5344A-01A-S

S E R V I C E N O T E

HP 5344A Microwave Source Synchronizer

Support Strut for the HP 5344A Microwave Source Synchronizer

Figure 1. HP 5342A/43A/44A Orientation and Support Strut Installation

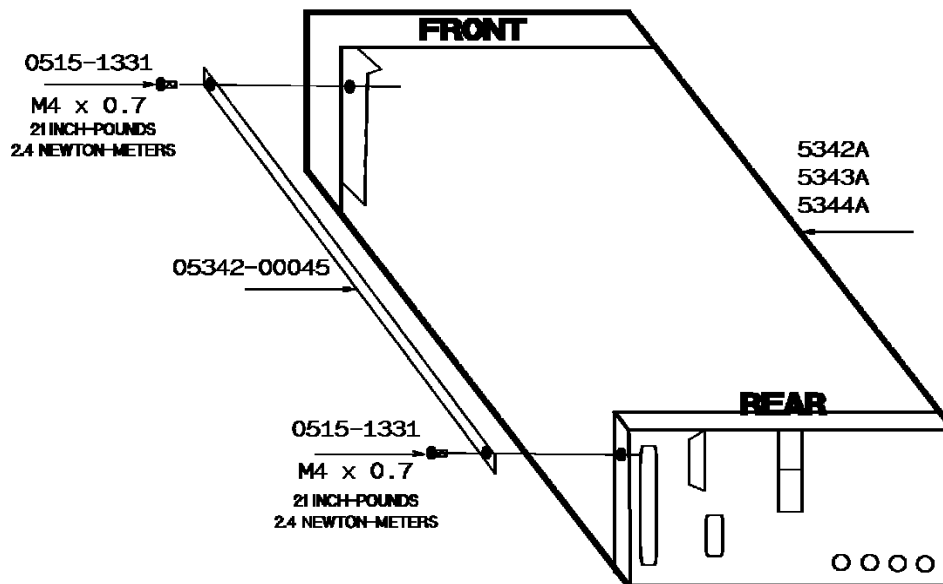
The cabinet framework of HP 5342A/43A Microwave Frequency Counters and HP 5344A Microwave Source Synchronizers with serial prefix 2636A and below does not ensure that the front and rear castings will remain in parallelism. When the front and rear castings are out of parallelism, it creates a condition where the top cover may not be fully captured, and could work loose upon application of an added force. Since the carrying handle is attached to the top cover, the unit could fall if it is lifted by the handle.

1. At top rear of HP 5342A/43A/44A, remove pozidrive screw from rear cap retainer and remove retainer.
2. Slide top cover back until free from frame and lift off.
3. Attach support strut, P/N 05342-00045, to the top left side of the cabinet framework with two metric screws, P/N 0515-1331. See Figure 1 for proper orientation of the HP 5342A/43A/44A.

Installing a support strut eliminates this potential safety problem.

4. Measure the top cover from the front end to the fold of the back end. If it measures less than 469.6mm, then replace the top cover with P/N 05342-60074. Add Operating Label, P/N 7121-2608, to the new Top Cover.
